Re Objection to 2021/4585/P

I am the freeholder of the neighbouring property at 109 Canfield Gardens and wish to strongly object to planning application **2021/4585/P**. I note that the previous very similar application **2019/4089/P** for installation of a car lift at the same property was rejected last year and had over 60 responses making objections. The main reasons for rejection were that the applicant had not been able to demonstrate sufficiently that the proposed works would not cause harm to the structural, ground or water conditions and that the application promotes use of private motor vehicles. Although this proposal now includes creating a very small grassed area in the front garden which might help a little with absorption of rainwater, I can see very little significant change from the previously rejected proposal.

PHOTO OF REAR GARDEN 109 CANFIELD GARDENS AUGUST 2021.

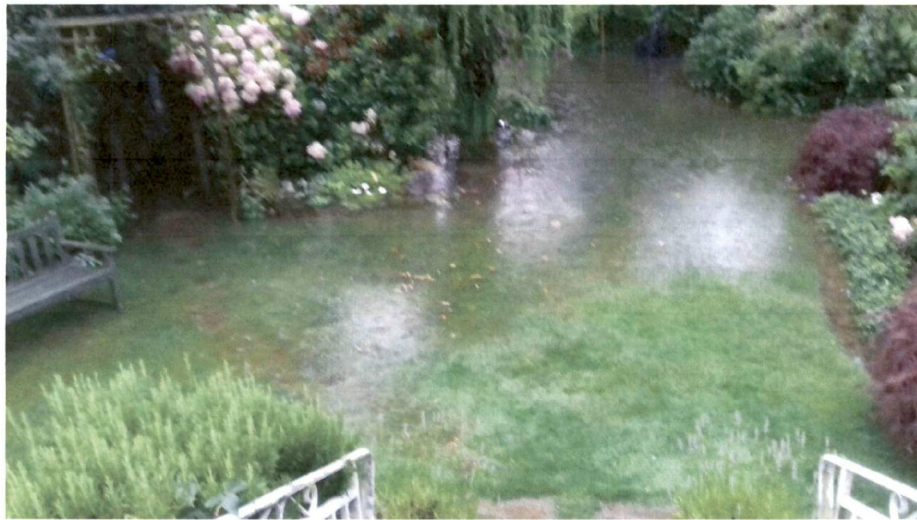
There is also already a problem of recurrent flooding in the rear garden at 109 which occurs every time there is very heavy rain. I am submitting this by letter too so I can include a photo taken in August 2021, showing the most recent evidence of this.

I am not convinced that the above problems of localised flooding have been taken into account in the overall assessment conclusions of this planning application. I also don't believe that the more recent ongoing trends in weather patterns have been taken into account because for example, the most recent rainfall report quoted dates back 24 years to 1997 since which time the climate has unfortunately changed considerably so we all need to do what we can to mitigate the potential effects!
